UNIVERSITY OF MINNESOTA University Hospitals
TWIN CITIES Minneapolis, Minnesota 55455

SUBJECT: Radiology Facility in B/C

SUBJECT: Radiology Facility in Building B/C

SUBJECT: Unit B/C
X-ray Room Details
Sheet E57

8 A34

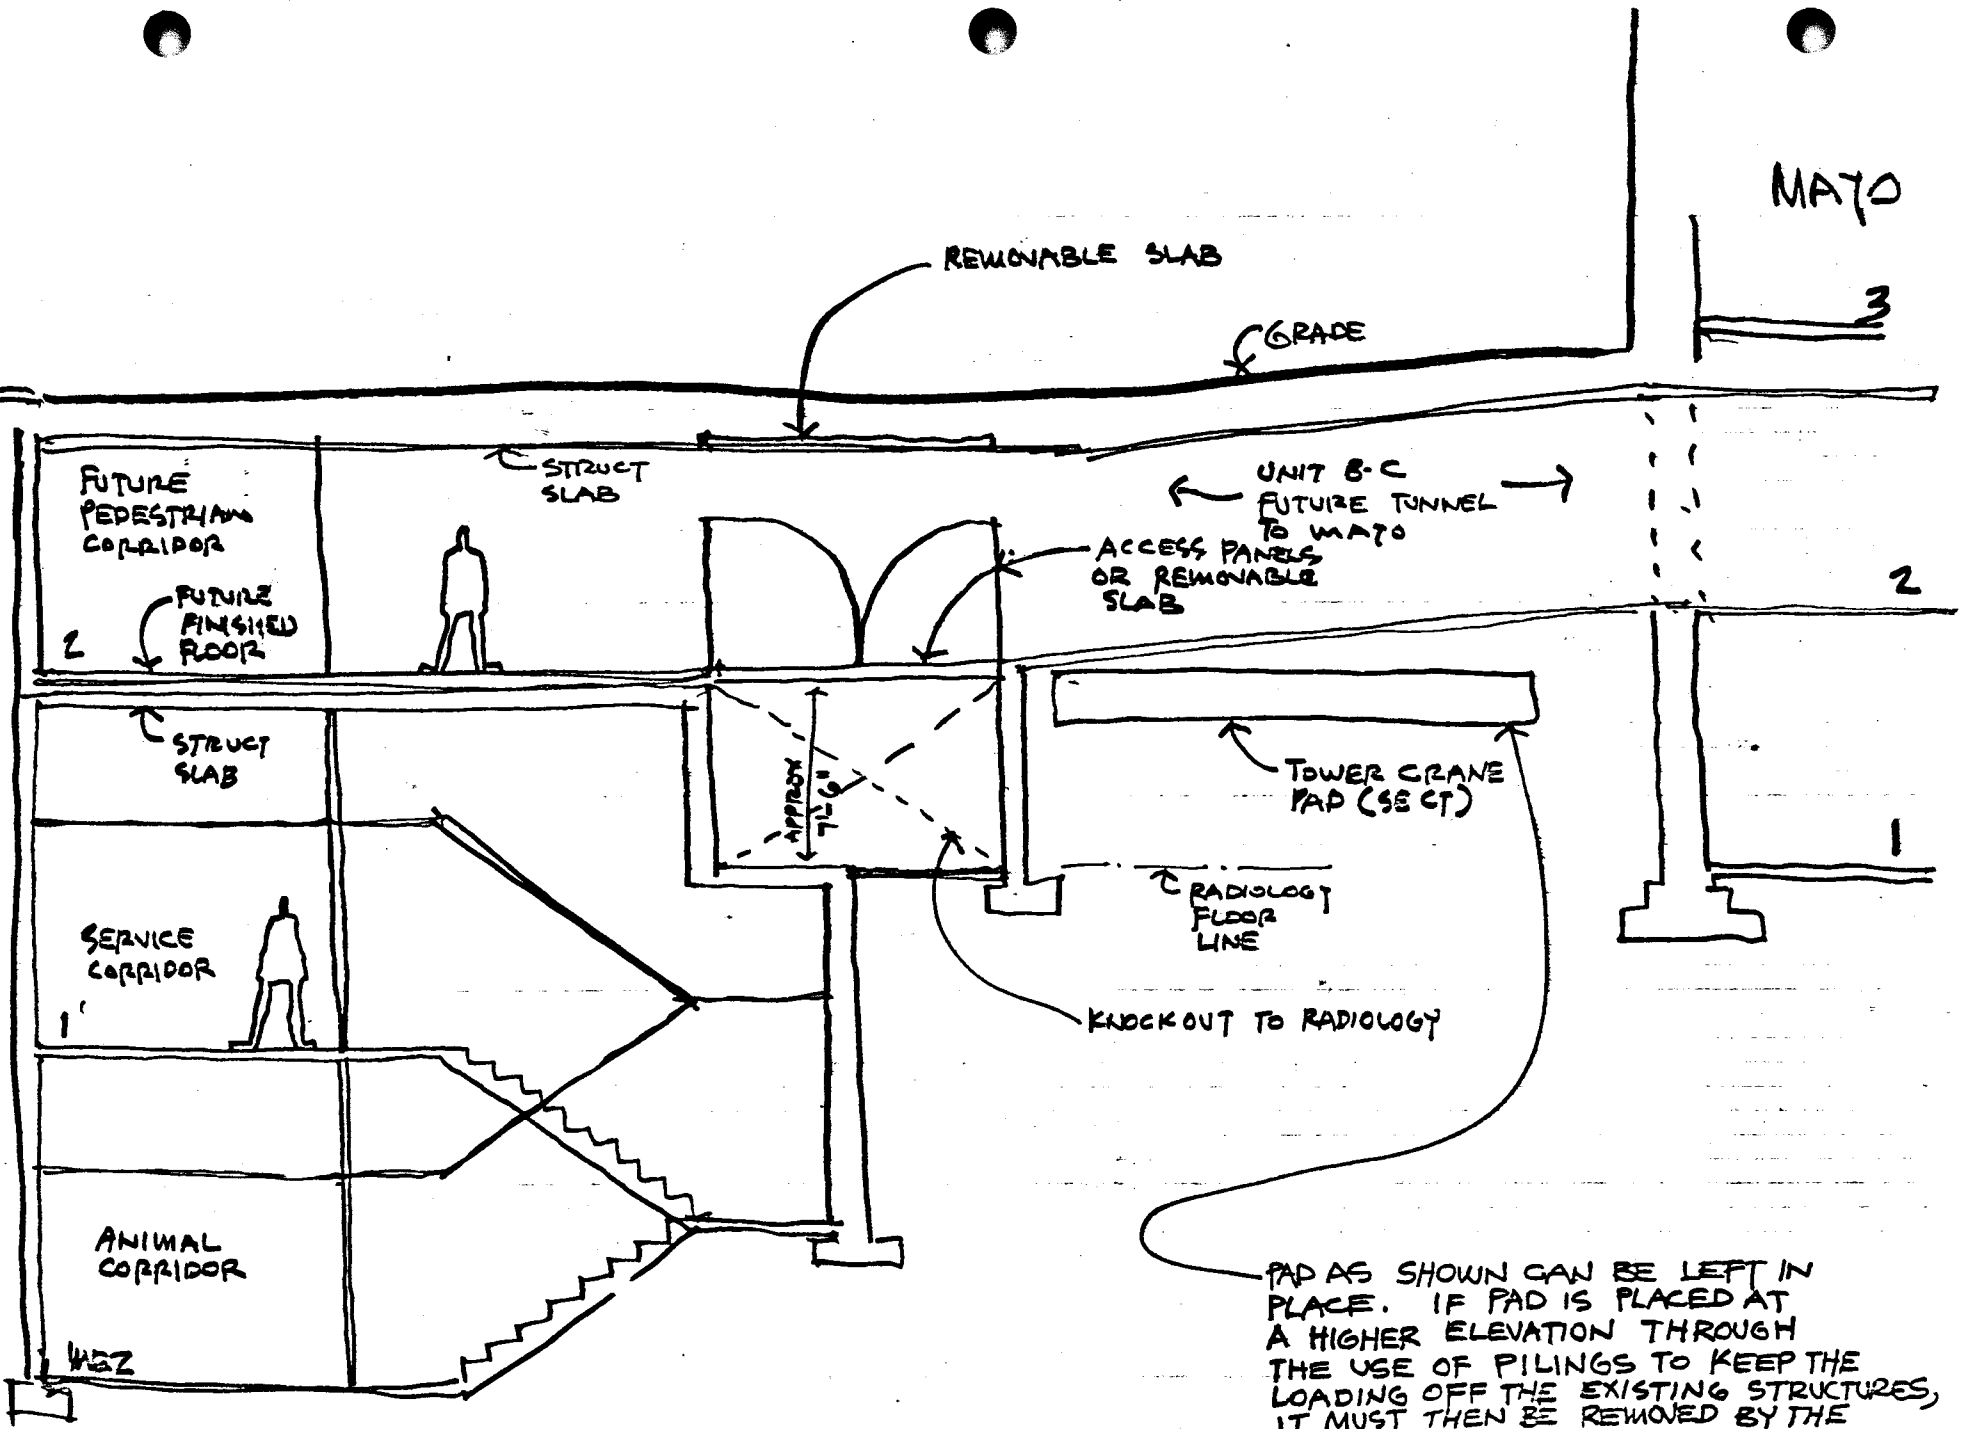
If in the future the Linear Accelerator is removed through this series of knock-out panels we expect the cost to remove and replace them to be substantial. This cost, however, may be low in comparison to the value of the Accelerator. If the Accelerator has no value we assume it could be dismantled and removed through the doors and corridors.

Please advise if our design assumptions are not correct or should be modified.

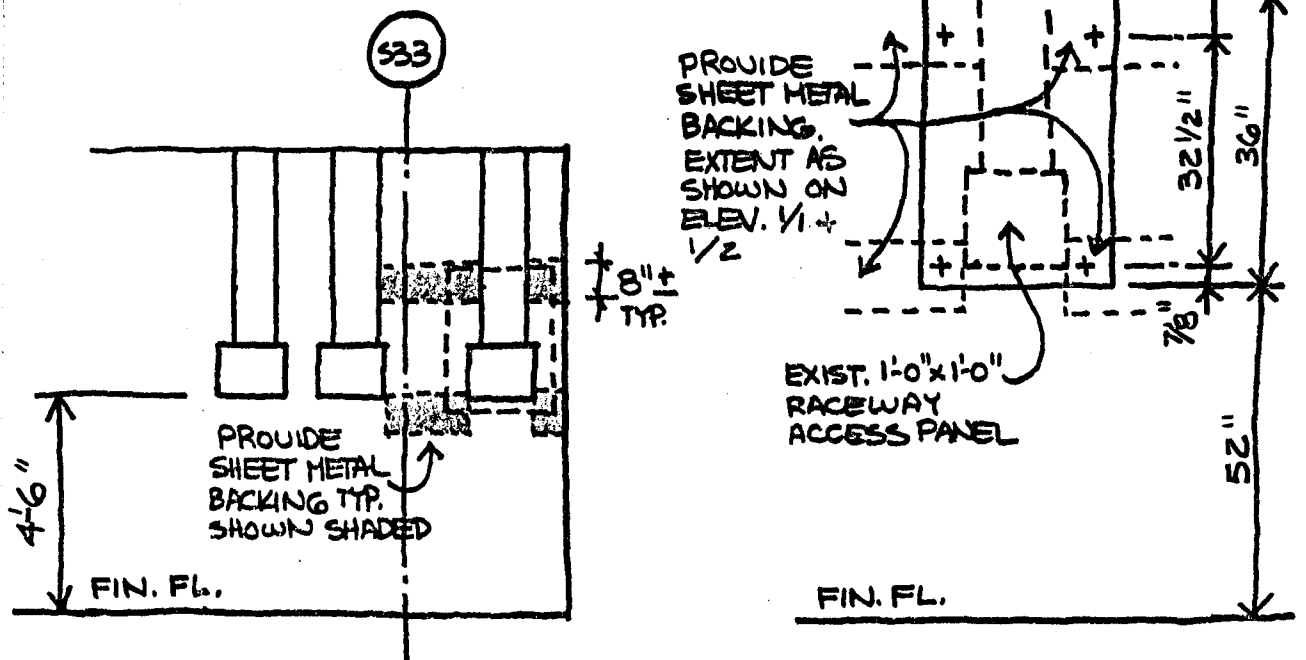
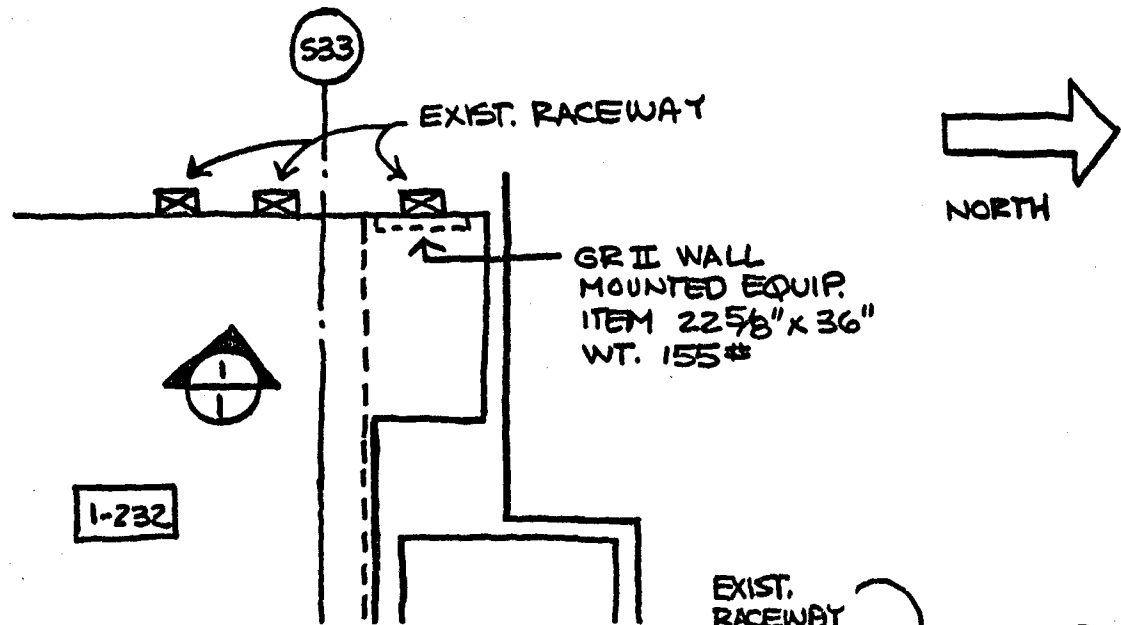
THE ATTACHED DRAWINGS INDICATE THE BACKING
REQUIREMENTS FOR ROOMS 1-232, 1-235, 1-240,
1-241, 1-242 + 1-243 LOCATED IN THE UNIT B/C
PHASE I RADIOLOGY CLINIC.

- ROOM 1-235 : R+F ROOM #2

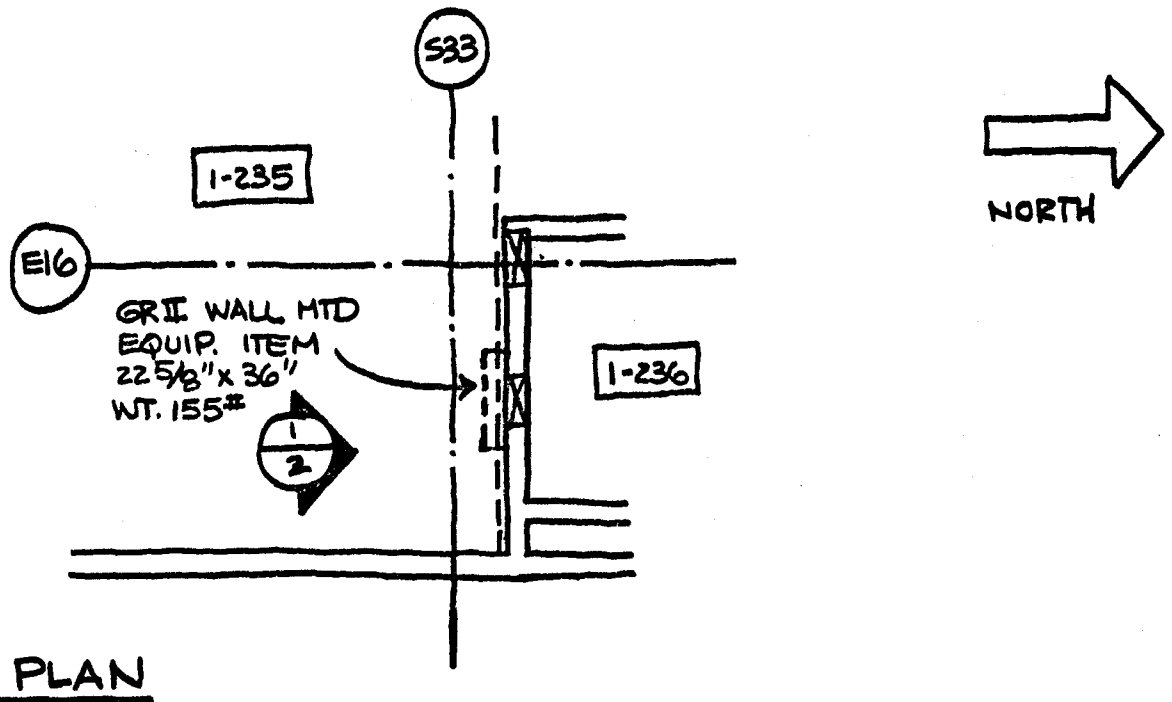
- OK b. Room 1-235 (R & F Room #2, Workload = 1000 mA-min/wk). The south and east walls of this room require 1/32" lead shielding to a height of seven feet, and the doors in the room require 1/32" lead shielding. The control barrier requires 1/32" lead shielding, and a lead glass window of the size designated in the plans. The west and north walls of this room require 1/32" lead shielding to a height of seven feet, however, the sections of the north wall along the toilet and a portion behind the control barrier, and the section of the west wall behind the control barrier, require no additional shielding. Again, the sections which do not require shielding are crossed out in red on the attached plans.

ROOM 1-243: CHEST ROOM

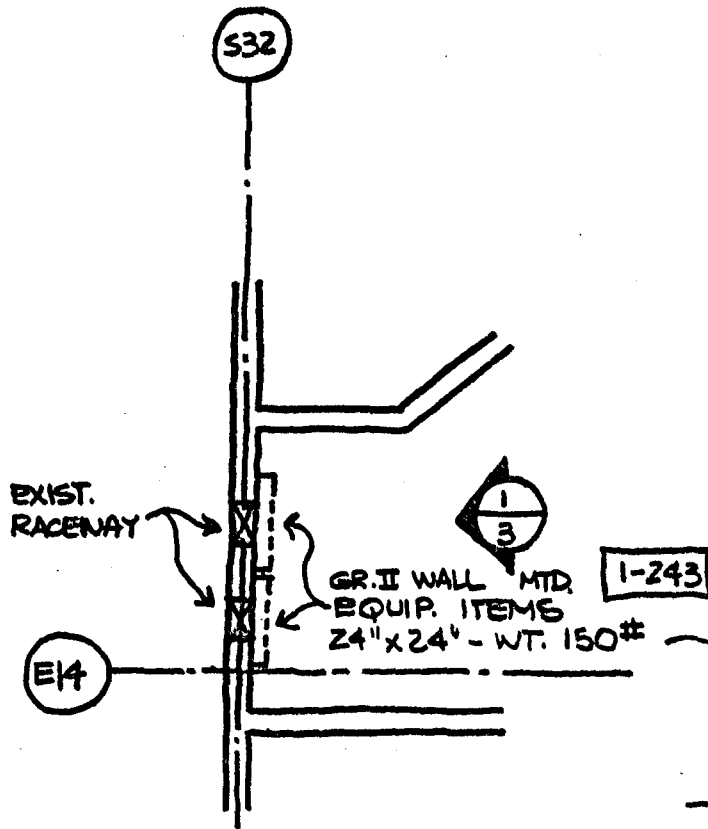
- OK c. Room 1-243 (Chest Room, Workload = 500 mA-min/wk). The west, north and east walls require 1/32" lead shielding to a height of seven feet, and the door in the north wall requires 1/32" lead shielding. The control barrier requires 1/32" lead shielding, and a lead glass window of the size designated on the plans. The south wall requires 1/32" lead shielding to a height of seven feet, however, the section of this wall and the door located behind the control barrier, requires no shielding (as indicated in the plans).

ROOM 1-240 : RADIOGRAPHY

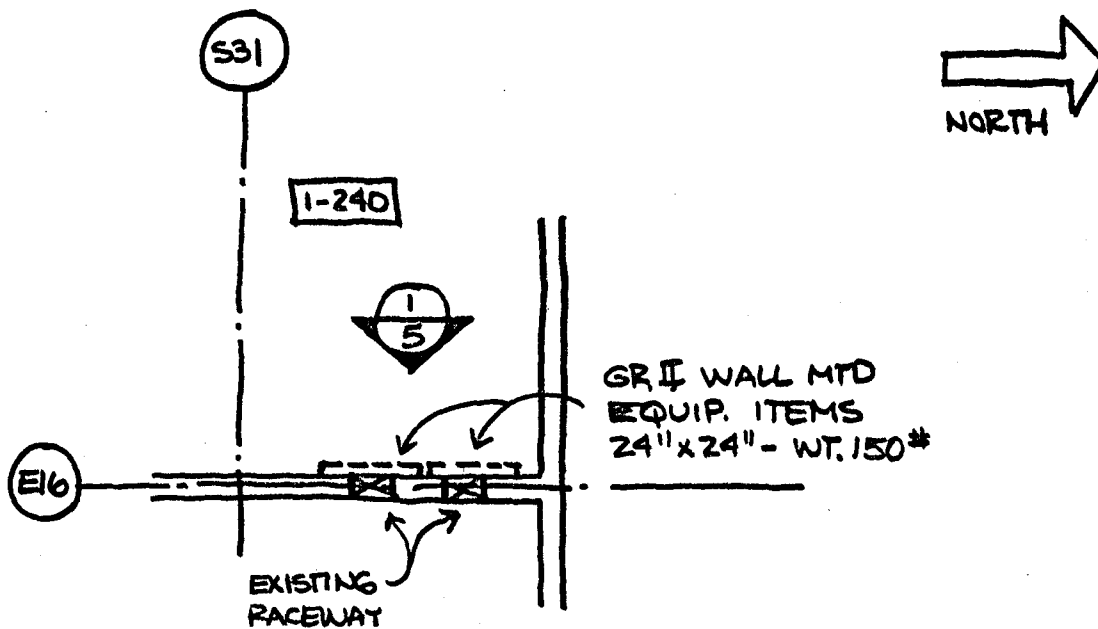
I have reviewed this letter against the Unit B/C contract documents and find only one item which requires a building change. (See page 2, item e, "south wall and door require the addition of 1/32" lead to a height of seven feet".)

Please provide the lead shielding protection required on door 1-240 and fund this change out of the cash allowance provided in the original construction bid for use in the Radiology department.
